From: Miguel Bautista - SFRD <mbautista@scappoosefire.gov>
Sent: Monday, March 10, 2025 5:30 PM
To: Planning Department.UserGroup
Cc: Charissa McGinn; Jeff Pricher - SFRD; Karleigh Booth - SFRD
Subject: FSAR 57269 Walker RD Scappoose OR SFRD Comments
Attachments: FSAR 57269 Walker RD Scappoose OR SFRD Comments.pdf

FIRE SERVICE AGENCY REVIEW

Address of Site: 57209 Walker Rd Scappoose, OR 97054

Fire Service Agency Review

MAY RESIDENCE SITE PLAN

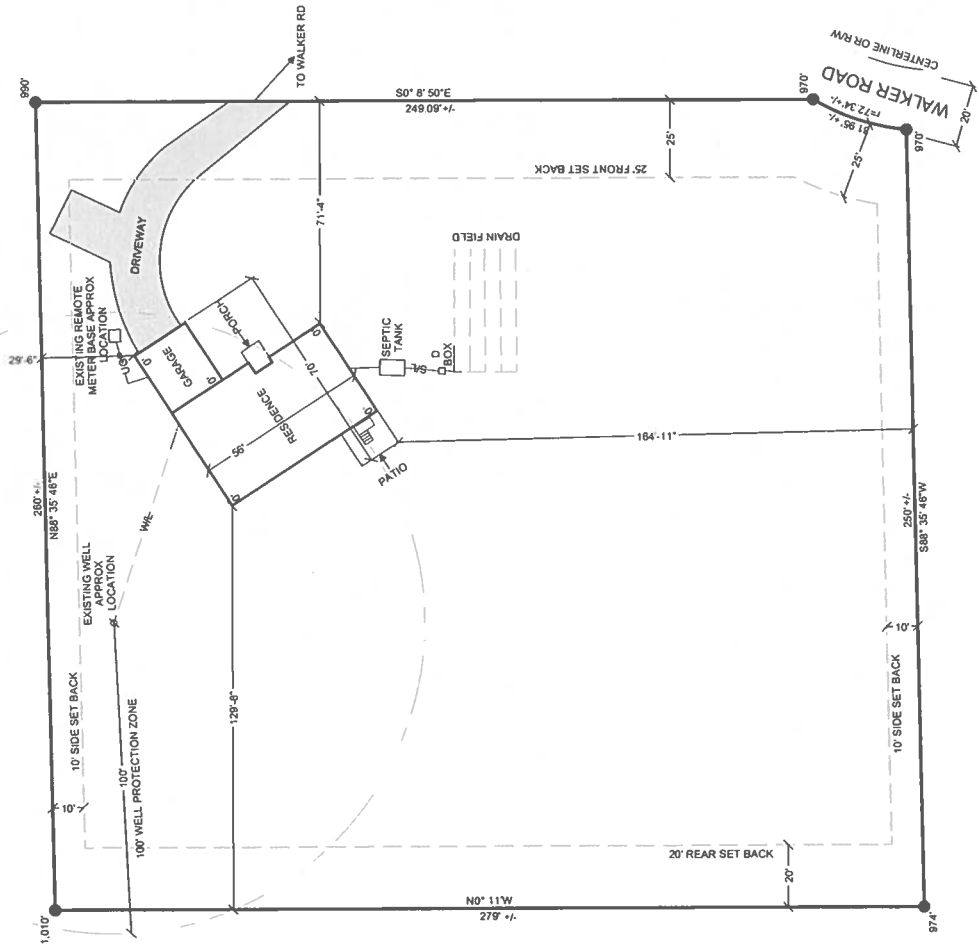
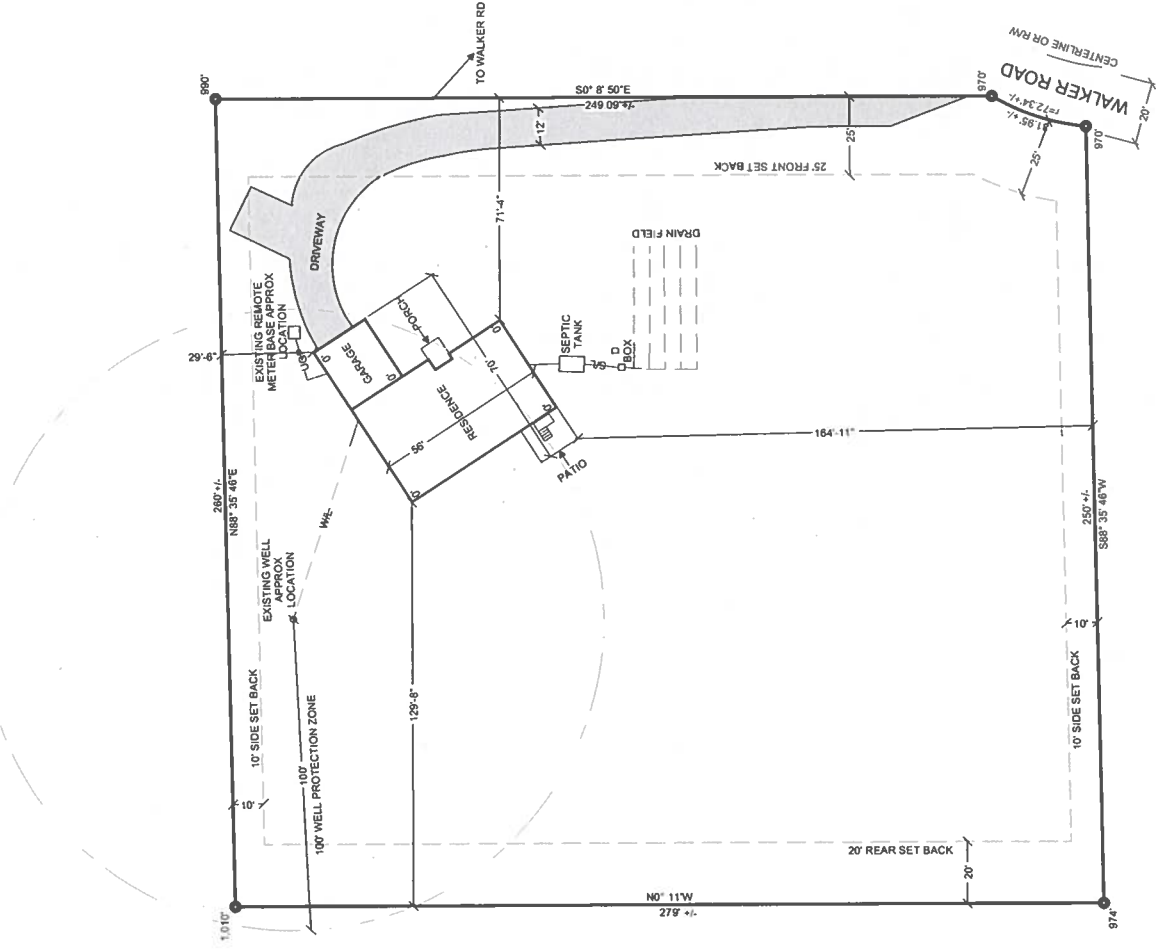
This document serves as notice that an initial inspection was conducted at your property, 57049 Walker RD Scappoose, OR 97056. After the inspection, we are able to grant **temporary access with re-inspection prior to occupancy with the following conditions needing to be met. Any changes to the original site plan shall be approved by the fire official.**

1. **A fire official approved fire apparatus turn around must be installed on the property.**

2. Address signs need to be posted on driveway access from Walker RD, at driveway split and the on the new home.

3. Clear 13' 6" vertical clearance.

4. Driveway shall meet the requirements of the Columbia County Fire Services Fire Apparatus Access Roads & Driveway Standard (Section 5.3 A of the Columbia County Fire Services Fire Apparatus Access Roads & Driveways Standard)

5. Driveway is 24% grade from approach off Walker Rd and reduces to 15% at the driveway split. Residential fire sprinklers are required to be installed, and paving is required for the driveway.

Turnarounds, cul-de-sacs, and other turnaround configurations shall be provided as required by the Oregon Fire Code 503.2 and Appendix D, and meet the following conditions (refer to diagrams page 6 of the Columbia County Fire Services Fire Apparatus Access Roads & Driveways Standard):

Driveways shall be marked with the residence's address unless the residence or building is in such a position as to be plainly visible from the roadway. The residence or building address must be legible from the street or road fronting the property. Letters or numbers should be a minimum of three inches in height and constructed of reflectorized material or as required by the Columbia County Addressing Ordinance, see OFC 503.3.

All fire apparatus access roads shall be at least 20 feet width of firm, uniform all-weather surface capable of supporting gross vehicle weights of 75,000 pounds and minimum wheel load of 12,500 pounds, a minimum curve radius of 45 feet and have a clear height of 13 feet, 6 inches and be maintained clear of debris/obstructions, see OFC 503.2.1 to 503.2.7 and Appendix D.

Driveways shall be built and maintained to provide a minimum 12- foot width of firm, uniform all-weather surface capable of supporting gross vehicle weights of 75,000 pounds and minimum wheel load of 12,500 pounds. Written verification of compliance by an Oregon Registered Engineer may be required. The 20 foot right of way shall consist of a 12 foot firm, uniform all weather travel lane bordered by a 4 foot section on each side which shall be maintained clear of debris and obstructions. Driveways shall have a minimum curve radius of 45 feet and a vertical clearance of 13 feet 6 inches. See OFC 503.2 and Appendix D.

Grade for fire apparatus access roads shall not exceed 12 percent with a maximum of 15 percent on short pitches, defined as no more than 200 feet in length. Where there are existing conditions, which exceed these parameters, the Fire Code Official will require additional road improvements and fire protection. These additional measures include paving of the problematic sections of road surface, wider road widths, and/or special fire protection systems, such as approved, monitored smoke detection systems and fire sprinkler systems. In no instance shall a

grade exceed 17 percent. Refer to OFC 503.1.1 in considering a variance of this interpretation and the Fire Code, see OFC 503.1, OFC 503.2.7, and Appendix D.
